**STOREFRONT
MODIFICATIONS
TO**

150 WORTH AVENUE UNIT 225
PALM BEACH
FLORIDA 33480

RFI 136

UNIT 219 AND 225

1 **SITE PLAN**
Scale: 1" = 20' ft

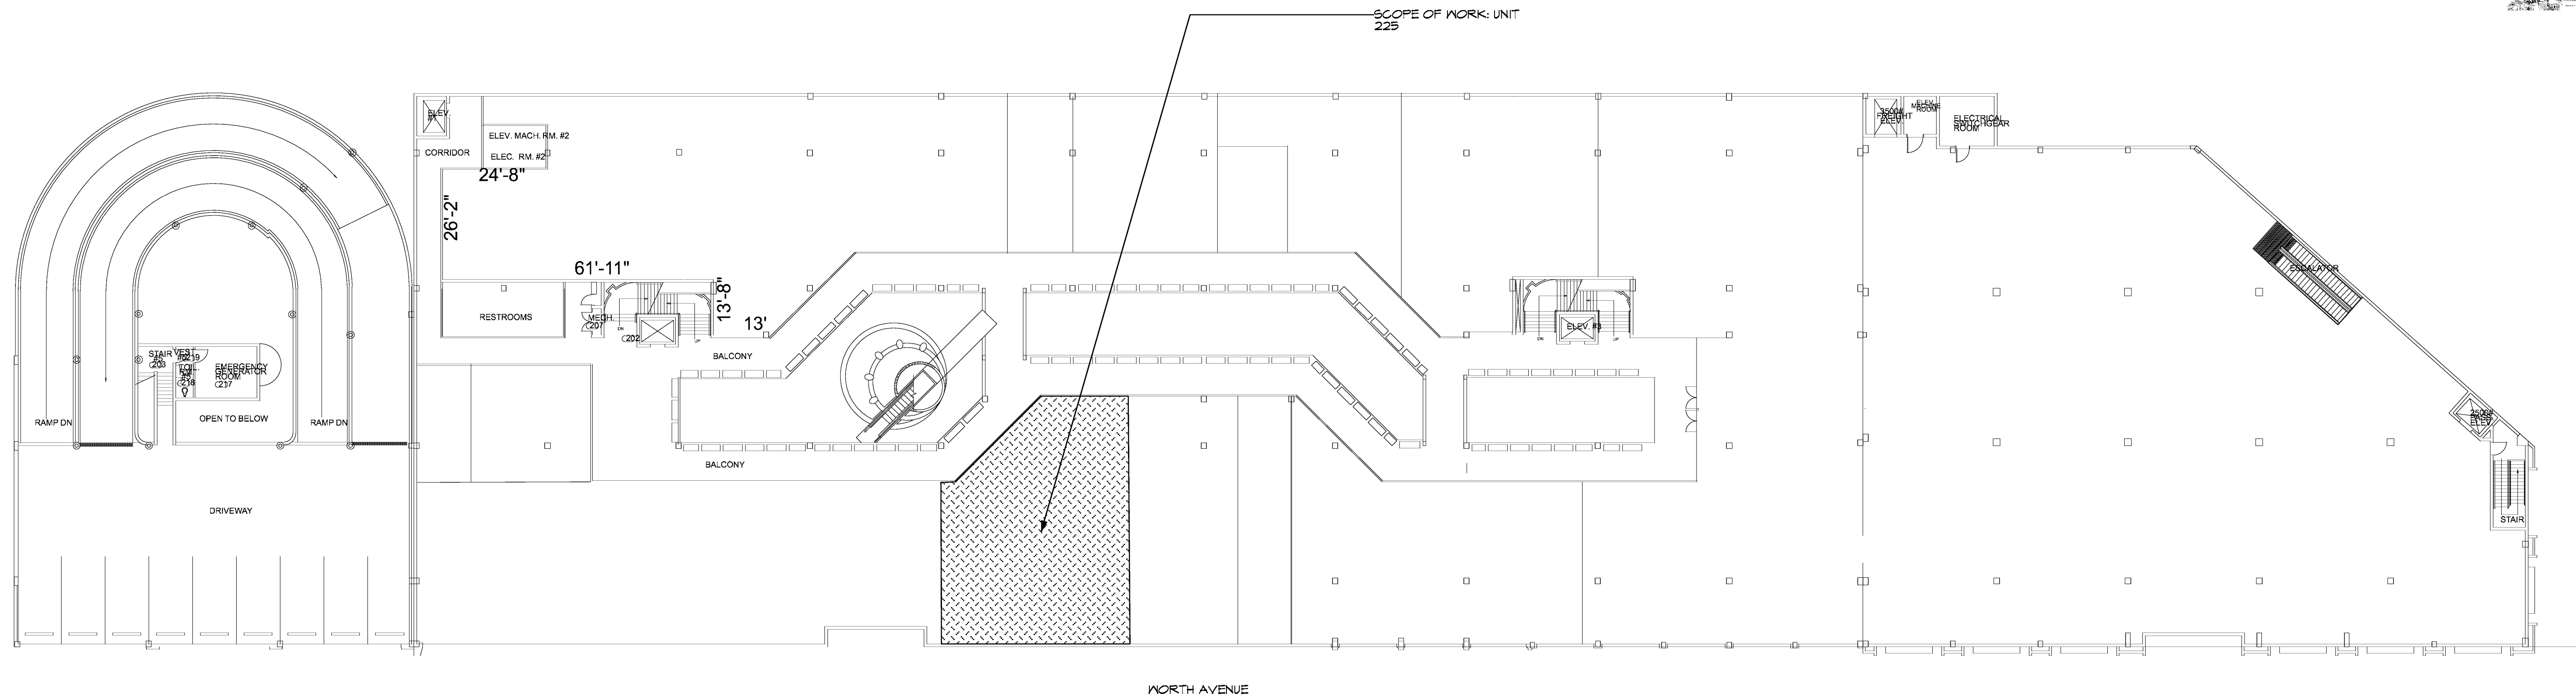
Sheet A0 indicates to remove and replace the existing storefront system, however, no information is provided for the new system with the exception of the wind design criteria. Please provide specifications. **SEE REVISED DRAWINGS**

1 STOREFRONT DEMO PLAN
Scale: 3/16" = 1'-0"

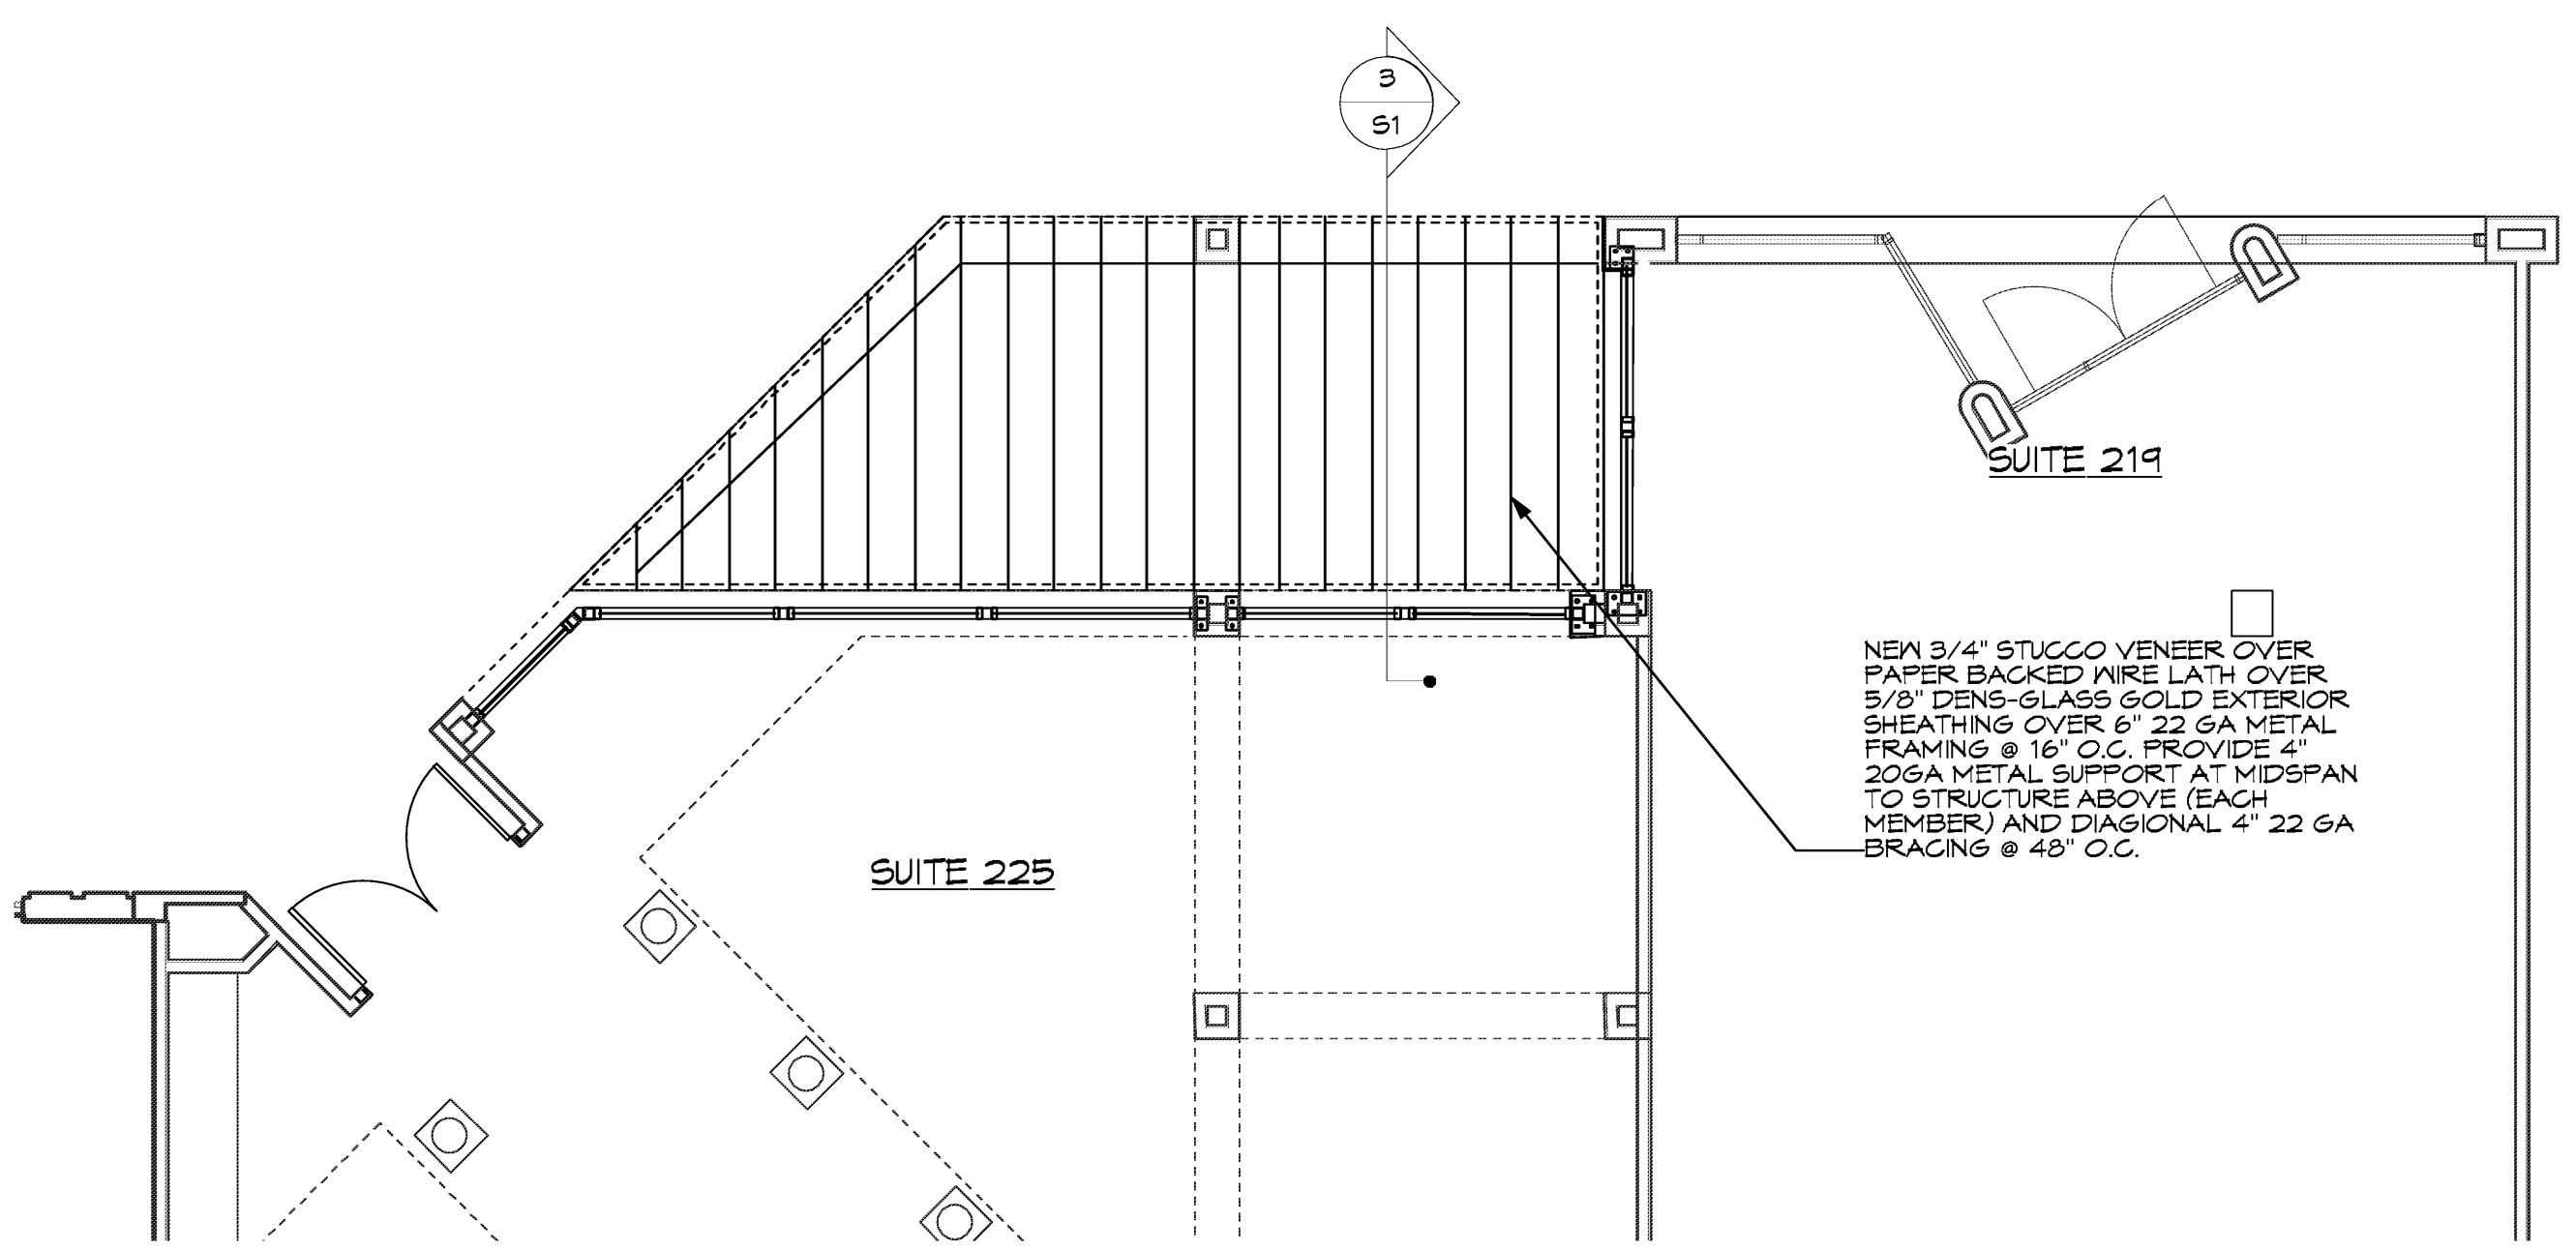
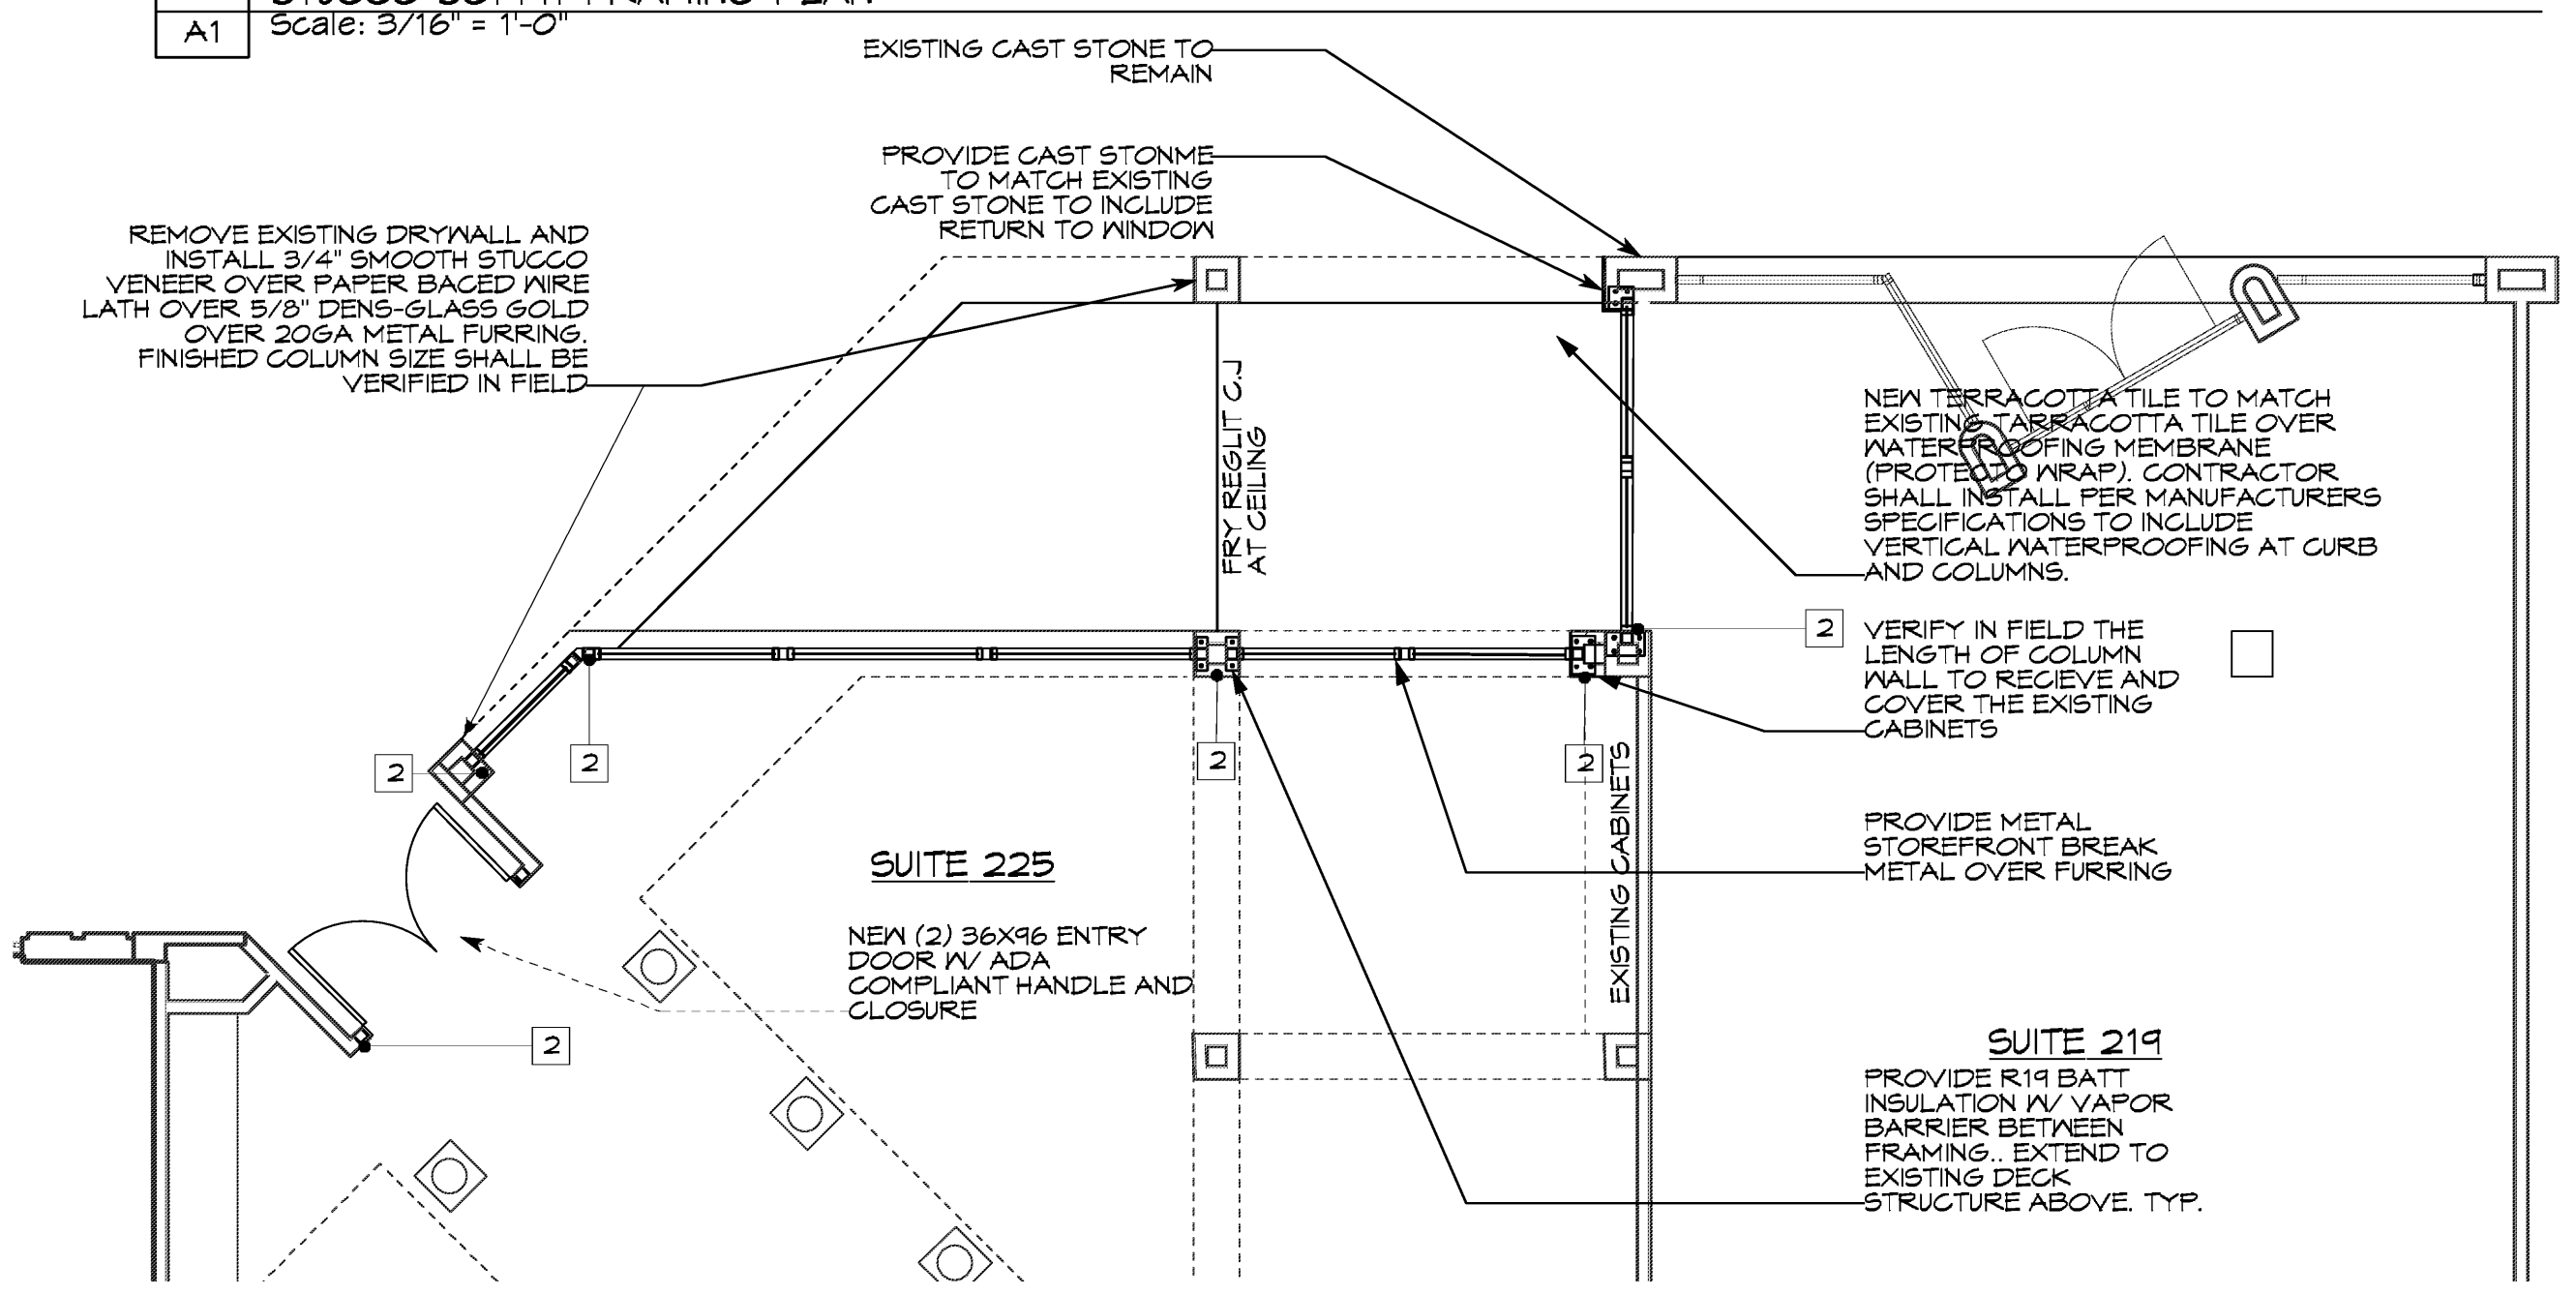
There is no demolition plan associated with the removal of the storefront system and associated components. Will any shoring be required prior to the removal of the existing storefront assembly? **SEE DEMO PLAN SHEET A1**
